M-1998-080

RESPONSE TO DRMS BOND
ESTIMATE

SUBJECT: M1998-080 H&H Quarry #2

Map 1. From aerial photo OCT 2012, showing affected areas (labeled, see Table 1) as of April 2014.

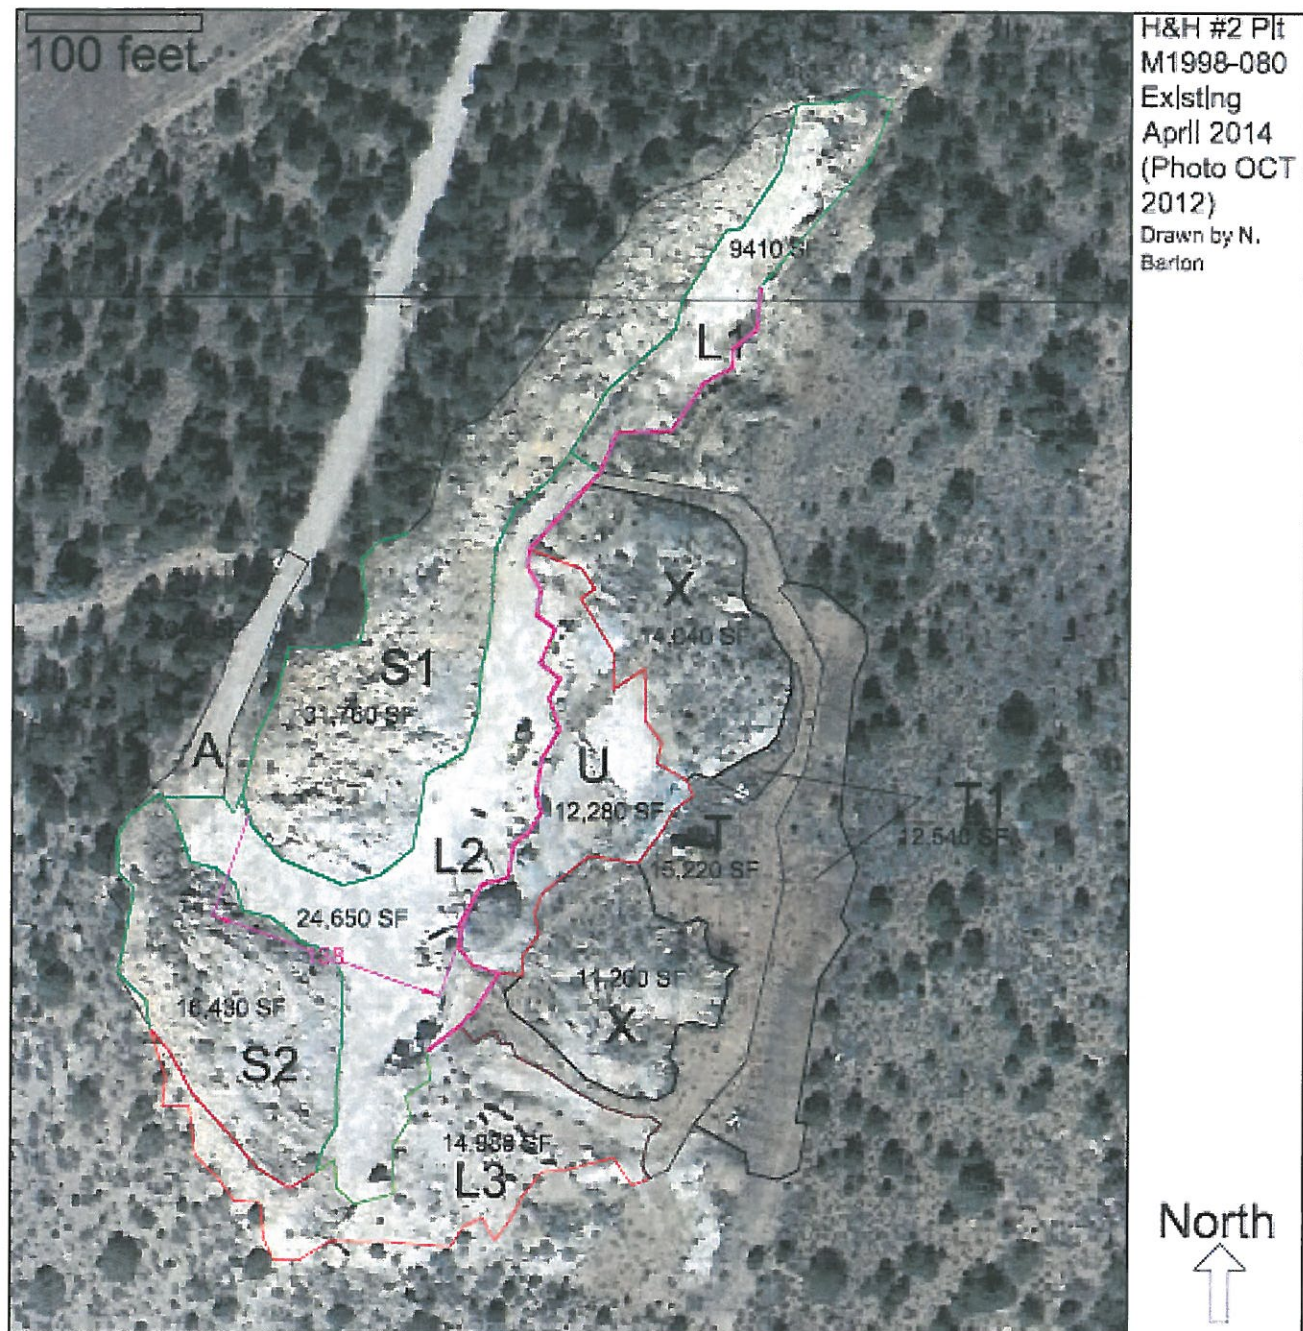
As shown on the attached map and table, which is based on both site reconnaissance and satellite photography, the total disturbed area, including the access road (ramp) is 3.30 acres. This was determined by using a scaled satellite photo and AutoCAD (Maps 1 and 2). The total area inside the perimeter is 3.8 acres, but this includes two areas which have not been disturbed by mining.

The site is divided into three areas: the lower level on which material is stockpiled and processed, a bench face/work area, and the upper level on which some equipment is parked and soil stockpiles and traffic areas are maintained.

Map 2. Map showing affected areas (labeled, see Table 1) as of April 2014.

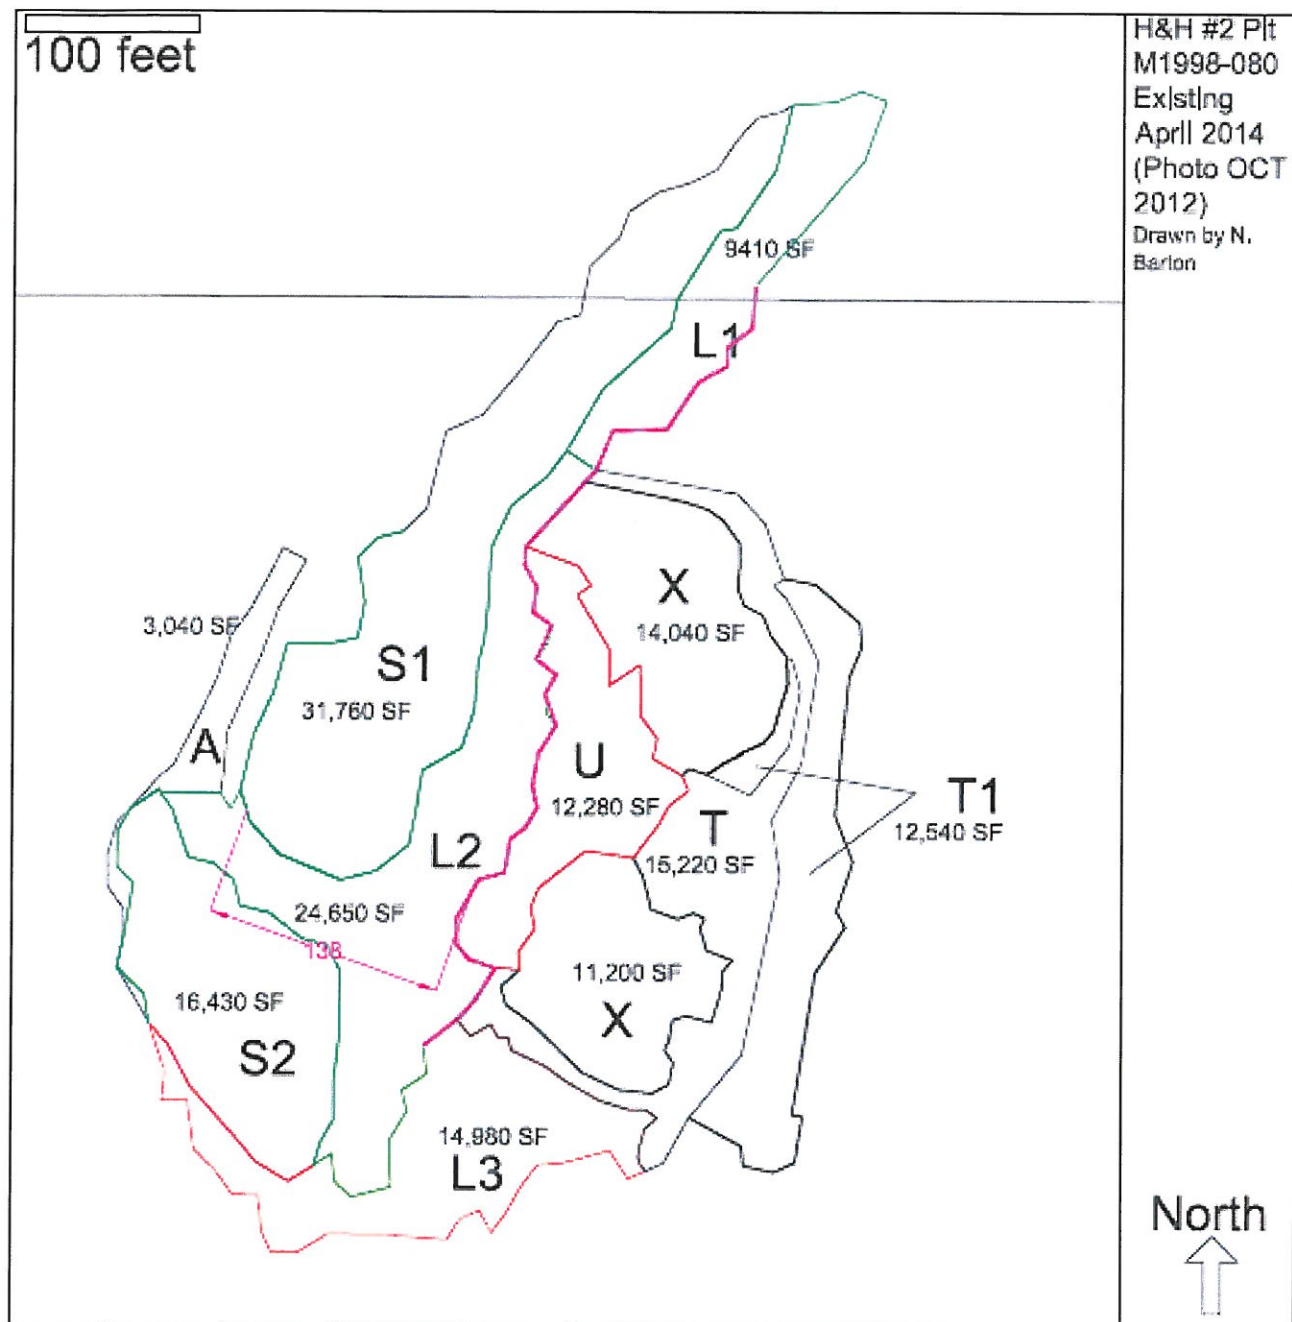
As can be seen in 1993 satellite/aerial photography, much of the site was already in rock outcrop, and soil existing on the site was very limited. Although the soil descriptions for the typical Romberg-CrossCan-Rock Outcrop indicate that 20% of the surface is rock outcrop and 35% is the deep Romberg, pre-mining photos indicate that this particular area has at least 35% rock outcrop, and significantly less Romberg (perhaps as little as 15%). In addition, the entire 60-inch profile of the Romberg is "very stony," and the CrossCan soil (only 18 inches to bedrock) is "very bouldery" to "very gravelly." (That is the soil that was salvaged and is located in stockpiles on the upper level.)

The highwall is estimated to be 580 feet in length (cyan line on Map 2), and consists of the exposed sandstone, mostly in large (8 ft to 20 ft high, up to 20 feet wide, 10 feet or more deep), which are very stable. Some areas are significantly fractured but still stable. Although the original application indicated there was some overburden (and may refer to the darker band of shaly sandstone between the caprock
